DELEGATED APPLICATION REPORT

App Ref: **PL/25/0312** Householder planning permission and App Ref: **PL/25/0313** Listed building consent

Address: 144 SOUTHAMPTON STREET, READING, RG1 2RD

Proposal: External and internal renovations and landscaping to the front garden to include alteration to front boundary wall and one parking space (part retrospective)

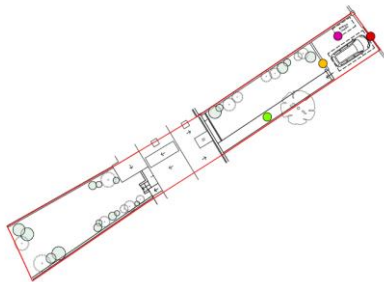
3.1 This application should be rejected for the reasons stated. In particular the parking space is entirely unacceptable.

3.2 An informed judgement cannot be made on most of the works proposed because the documentation submitted is not sufficiently explicit about the changes to be made and how they impact the heritage asset.

3.3 Should this application be approved as it stands, a long list of conditions will be required to protect against works which may be undertaken but could have significant impact on the heritage fabric and appearance of the building.

3.4 Our conclusion is that the application does not comply with policy EN1 Protection and enhancement of the historic environment.

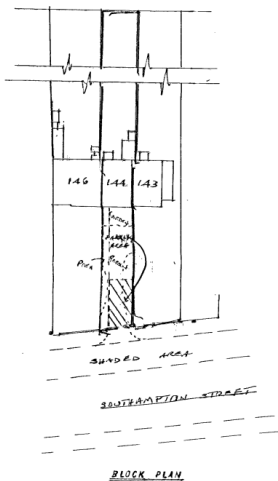
The proposals would allow for the building to be used as a single family dwellinghouse, which is the original use of the building and is considered the most suitable use which would be highly beneficial.

Although the loss of part of the original front boundary wall has resulted in some harm, this has been weighed against the benefits of using the building as a family home with the benefit of an off-street parking space for the property.
